Upgrade to North Sydney Public School - Modification 1

State Significant Development Modification Assessment
(SSD 11869481 MOD 1)

June 2022

Figure 5 | Proposed new cleaner's room and relocated library entry doors outlined in red (Source: Applicant's Modification Application 2022)

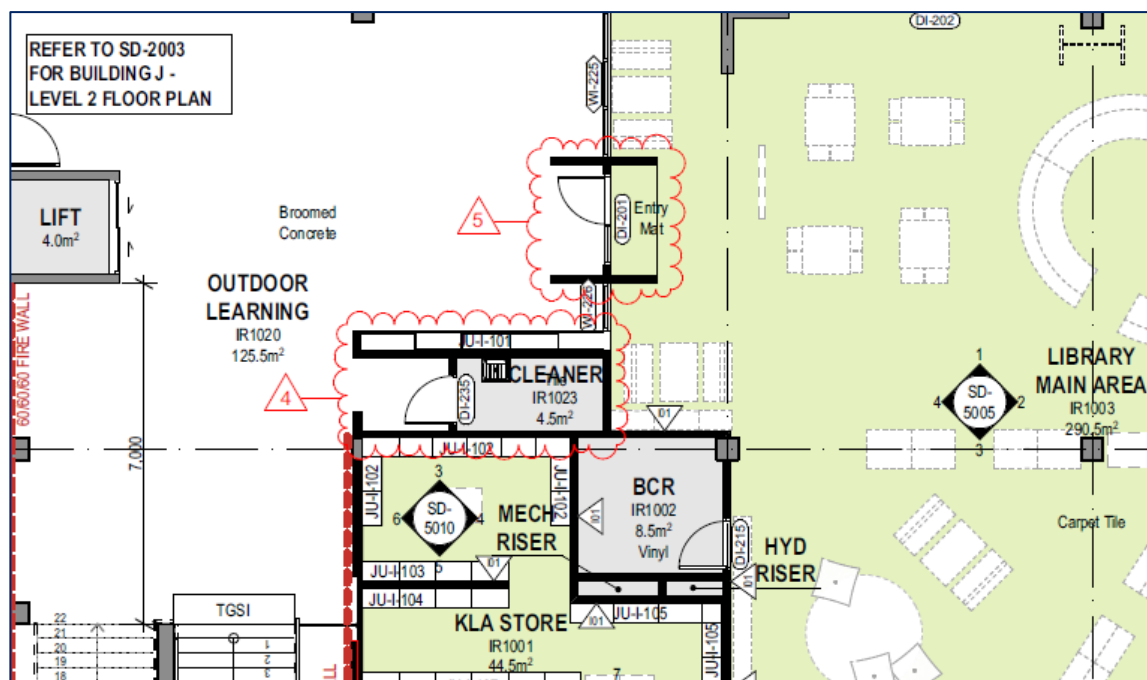
- relocation of approved library entry doors to accommodate a new cleaner's storeroom on Level 2 in Building I (**Figure 5**)
- realignment of approved western walls of plant and toilet rooms on level 3 of Building I (**Figure 6**)
- increased size, reconfiguration and minor changes to construction of fixed and openable windows across all three levels of the southern elevation facing Bay Road (**Figure 7**)
- amend the approved louvre doors on the southern elevation of Building J (**Figure 8**).

The Applicant states that the proposed cleaner's storeroom and realignment of library doors on level 2 and western walls on level 3, and the amended louvre doors fronting Bay Road on Building J are necessary as a result of ongoing detailed design of the approved development (**Figures 5 - 8**).

- the Applicant has demonstrated that the design modifications and ramp reconfiguration are required to meet relevant requirements of the BCA and EFSG
- the reconfigured ramp grade and handrail clearance will likely improve pedestrian safety
- the proposed addition of a cleaner's room, change to western walls and changes to window dimensions do not significantly alter the architectural form and appearance of the development and would not result in any adverse impacts to the Bay Road streetscape
- The design modifications to windows will have a neutral impact on the site's heritage values and surrounding HCA and heritage items.
- Council and GANSW did not raise any issue with the proposed modifications
- the alterations to window size and configuration will not result in additional acoustic impacts beyond what was assessed under the original SSD.

**Figure 7 | Sample of window changes to the southern elevation (Bay Road)
(Source: Applicant's Modification Application 2022)**

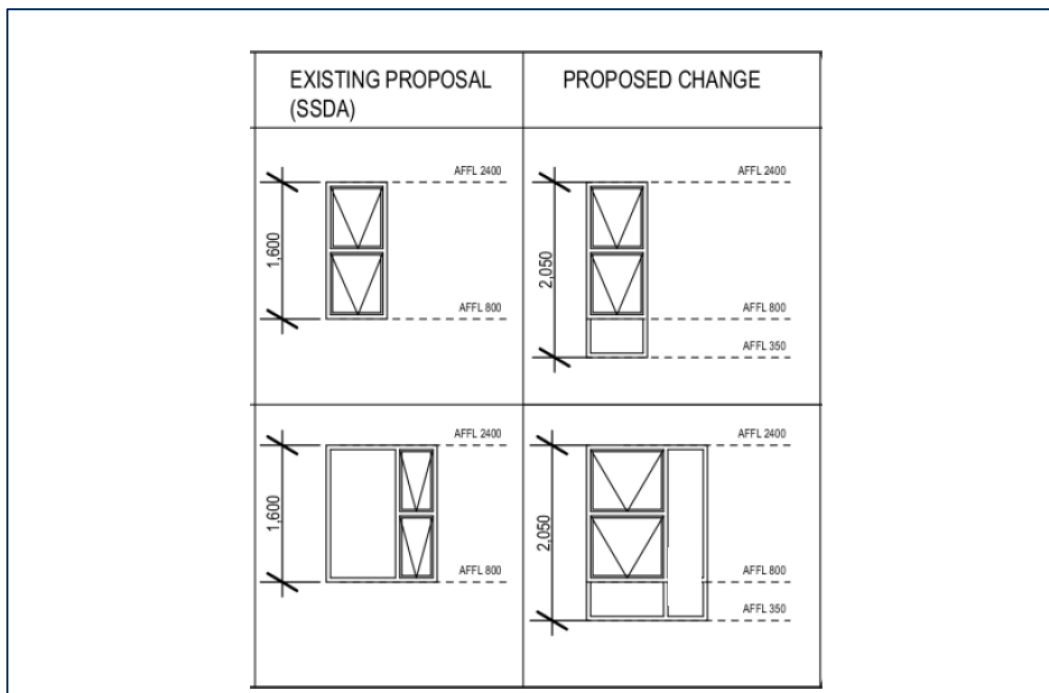
The modification application included a written justification of window changes prepared by Fulton Trotter Architects and an acoustic review memorandum prepared by Pulse White Noise Acoustics to support the proposed increased size, reconfiguration and minor changes to construction of fixed and openable windows across all three levels of south elevation facing Bay Road window. The modification application also included a Heritage Impact Statement (HIS) which provides an assessment of the proposed design modifications impacts on the heritage values of the site, the adjacent Priority Road Heritage Conservation Area (HCA) and three dwellings within close proximity of the site which are locally listed heritage items.

The modification application and written justification of window changes conclude that the proposed design modifications are required for compliance with relevant natural light and ventilation requirements contained within the BCA, and to meet required sill height, ramp grade and clearance requirements provided for home base windows and ramp configuration in the EFSG. The Acoustic review concludes that the proposed changes to the external window dimensions do not result in acoustic alterations relevant to the approval of SSD 11869481. The HIS concludes that the proposed design modifications to windows on the southern façade facing Bay Road will have a neutral impact on the heritage values of the site, adjoining HCA and surrounding heritage items.

Figure 9 | Proposed ramp reconfiguration (Source: Applicant's Modification Application 2022)

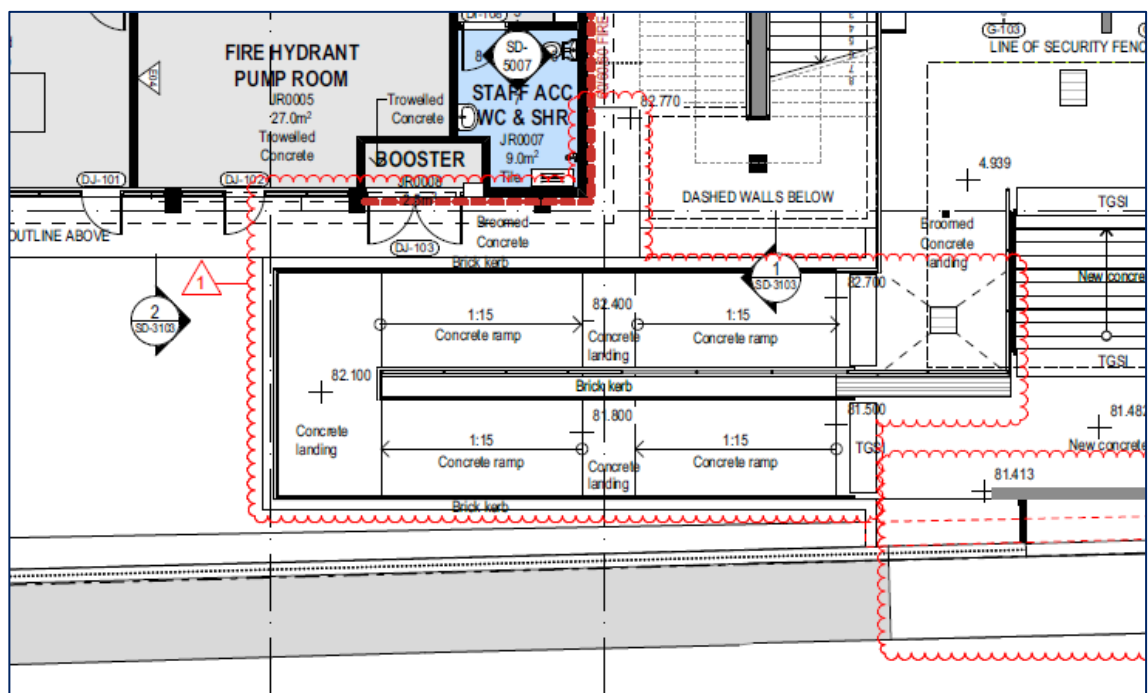
Proposed amendments to the pedestrian ramp adjoining the Bay Road pedestrian entry and gates includes an increased ramp grade from 1:14 to 1:15 with a widened clearance of 2.1m between handrails (**Figure 9**). The Applicant states the amendment is required for compliance with EFSG requirements.

The pedestrian ramp adjoining the Bay Road pedestrian entry was approved with a 1:14 grade and 2m clearance between handrails. Proposed modifications include an increased ramp grade from 1:14 to 1:15 with a widened clearance of 2.1m between handrails (**Figure 9**). The Applicant states the amendment is required for compliance with EFSG requirements.

Council made no comment with regard to the proposed design modifications or potential heritage impacts associated with the modification to windows. Council recommended that safety should be a design priority with respect to the ramp reconfiguration, and that consideration should be given to barriers, lighting, line marking and/or signage to promote pedestrian. Government Architect NSW

Figure 10 | Proposed modification to existing heritage fence
(Source: Applicant's Modification Application 2022)

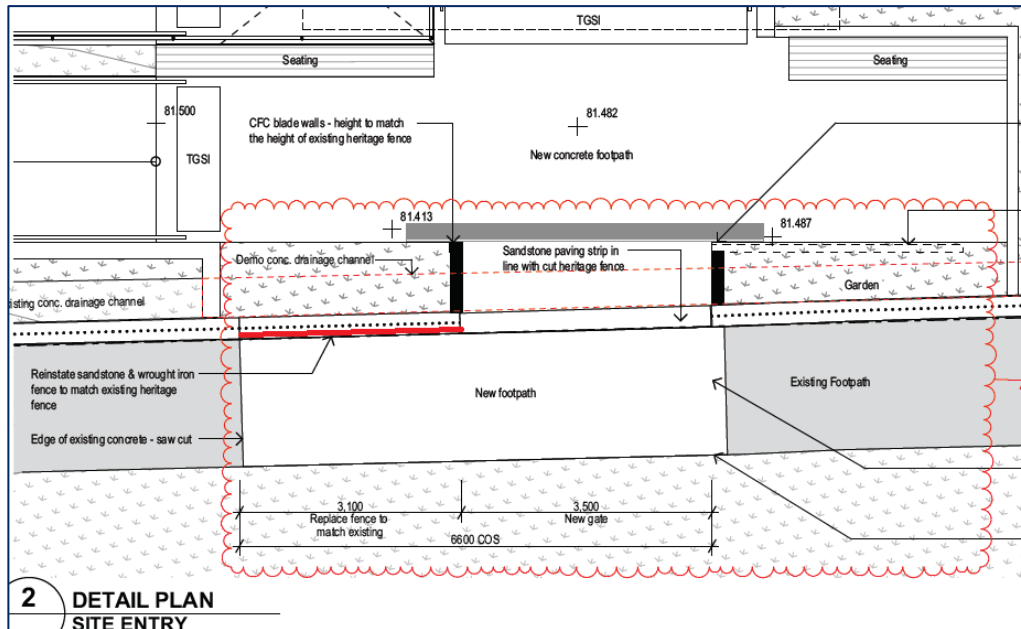
Proposed modifications to the existing heritage fence and stone gutter include the temporary removal of 3.1m of heritage fence and stone gutter adjoining the approved Bay Road pedestrian entry (**Figure 10 & Figure 11**). The Applicant states that the temporary removal is required to allow for safe and efficient construction access into the site from Bay Road.

- proposed modification to the heritage listed fence should be designed to maintain the heritage values, style and standard of construction as currently exists
- mature tree planting should be used to break up the bulk of the façade along Bay Road
- pedestrian safety should be a design priority and consideration should be given to barriers, lighting, line marking and/or signage to promote pedestrian safety at the Bay Road entry and ramp.

The wrought iron and sandstone portion of the school's boundary fence is listed as a local heritage item under NLEP. The approved Bay Road pedestrian entry included the permanent removal of a 3.5m section of the heritage fence and corresponding portion of stone gutter on Bay Road to provide a pedestrian entry and operable gate for access to the school from Bay Road. The modification application seeks to temporarily remove a further 3.1m section of the heritage fence and stone gutter directly adjoining the approved 3.5 permanent removal portion of the fence to provide a total width of 6.1m for construction access and egress (**Figures 10 & 11**).

The Department has reviewed the information provided by the Applicant, including the HIS, and considered the proposed temporary removal of the heritage fence and stone gutter in the context of the Department's original SSD assessment. The Department considers that the proposed temporary removal and reinstatement of the heritage fence and gutter is appropriate as:

- the temporary removal of the heritage fence and gutter will provide safe and efficient access to the site for construction vehicles and equipment

- the Applicant has demonstrated that the minor negative impact to the heritage values of the fence will be mitigated by the proper and orderly reinstatement of the fence once construction access is no longer required.

The Department has recommended conditions that requires the temporary removal, storage and reconstruction of the subject portion of the heritage fence and gutter to be undertaken in accordance with the recommendations of the HIS which include:

- appointment of a heritage specialist by the Applicant to oversee these works
- removal, storage and reconstruction of the fence and gutter to be in accordance with the methodology contained in the HIS
- photographic record to be undertaken of the heritage fence and gutter prior its temporary removal in accordance with NSW Heritage Office document 'Photographic Recording of using Film or Digital Capture' and provided to Council for information.

Figure 13 | Bay Road construction vehicle access and site manoeuvrability (Source: Applicant's Modification Application 2022)

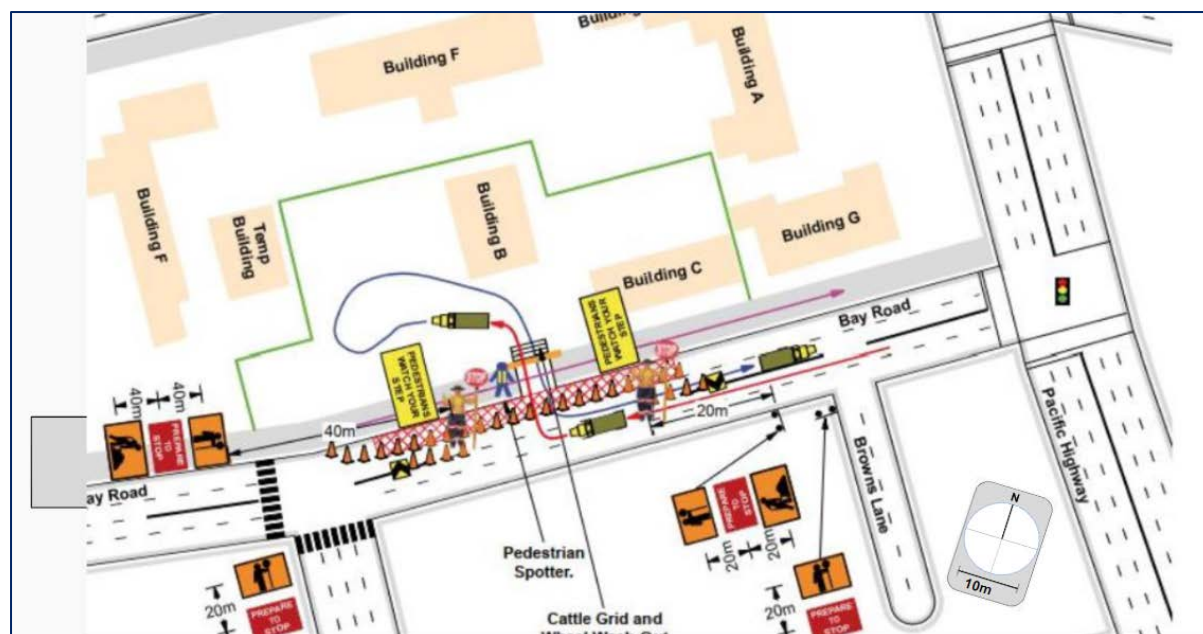
The rational report details how 12.5m rigid trucks would enter and exit the site in a forward-in and forward-out direction (**Figure 13**), and states that the minimum width required for a gate to be used by 12.5m rigid trucks is 6m. The proposed temporary removal of the heritage fence and gutter would provide a sufficient width of 6.1m for construction vehicles to safely enter and exit the site.
